To: T10 Technical Committee  
 From: Rob Elliott, HP (elliott@hp.com)  
 Date: 22 February 2004  
 Subject: 04-032r1 SAS-1.1 ALIGNs through expanders

Revision 1 (22 February 2004) Corrected rate matching minimum numbers in tables - from "2048 or 2050" to "2049" for non-STOP, and from "2064 or 2066" to "2065" for STP. There is still toggling going on in every other 2K window, but a 4K window always has one short 2K sections and one long 2K section, so they add together ("1024 + 1025" for non-STP and "1032+1033" for STP).

**Figure 1 — 1.5 Gbps to 3.0 Gbps connection**

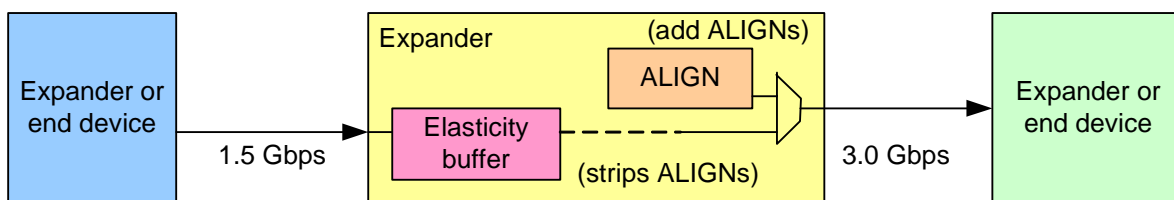
When an expander is forwarding dwords from a 1.5 Gbps link to a 3.0 Gbps link and inserting rate matching ALIGNs, the clock skew management ALIGN frequency requirement of 1 ALIGN every 2048 dwords cannot be met. Figure 1 shows the scenario.

As the expander forwards the dword stream, it has to insert rate matching ALIGNs as required on the 3.0 Gbps link to make up for underflows in the input 1.5 Gbps stream - 1 ALIGN every 2 dwords. Essentially, the transmitter underflows a lot. It is not allowed to buffer up N dwords and burst them out together, followed by N ALIGNs - it is required to dole out the ALIGNs every other dword so the receiver of the data is not required to have lots of extra buffering.

Additionally, The 1.5 Gbps source transmits 1 ALIGN every 2048 dwords for clock skew management (i.e., clock frequency tolerance compensation). Each of these ALIGNs creates additional underflows in the expander that consume two 3.0 Gbps dword widths of time. The expander probably sends the two 3.0 Gbps ALIGNs back-to-back. It could also scatter them, but that requires extra buffering in the expander.

**Figure 2 — ALIGNs on the links**

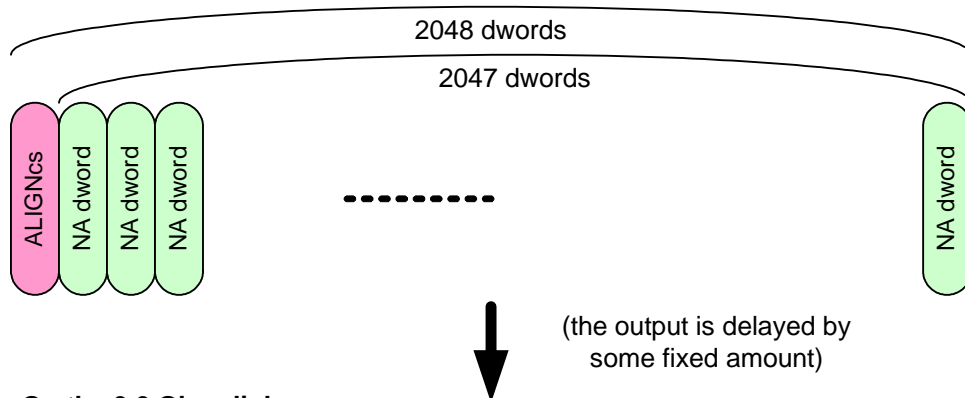
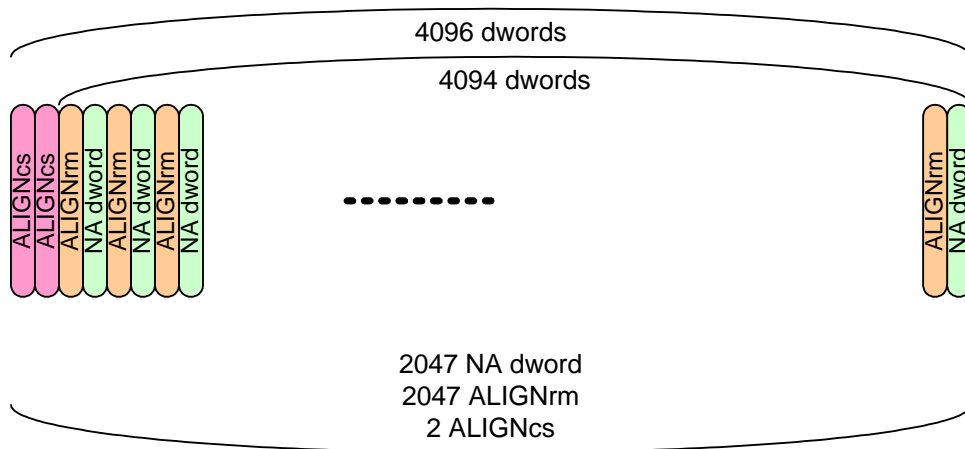
Figure 2 shows the dword stream on each physical link.

Of the 4094 dwords on the 3.0 Gbps link that are not the two clock skew ALIGNs, 2047 are the non-ALIGN dwords from the 1.5 Gbps link and 2047 are the rate-matching ALIGNs. There are no clock skew ALIGNs in that group - they appeared at the beginning (of the 4096 dword window).

So, on the 3.0 Gbps link, all that can be guaranteed is 2 ALIGNs every 4096 dwords, not 1 ALIGN every 2048 dwords. There are many 2048 dword windows where those ALIGNs might not both appear (inside the 4094 dword window). For 6.0 Gbps (in SAS-2), the ratio will grow to 4 ALIGNs every 8192 dwords.
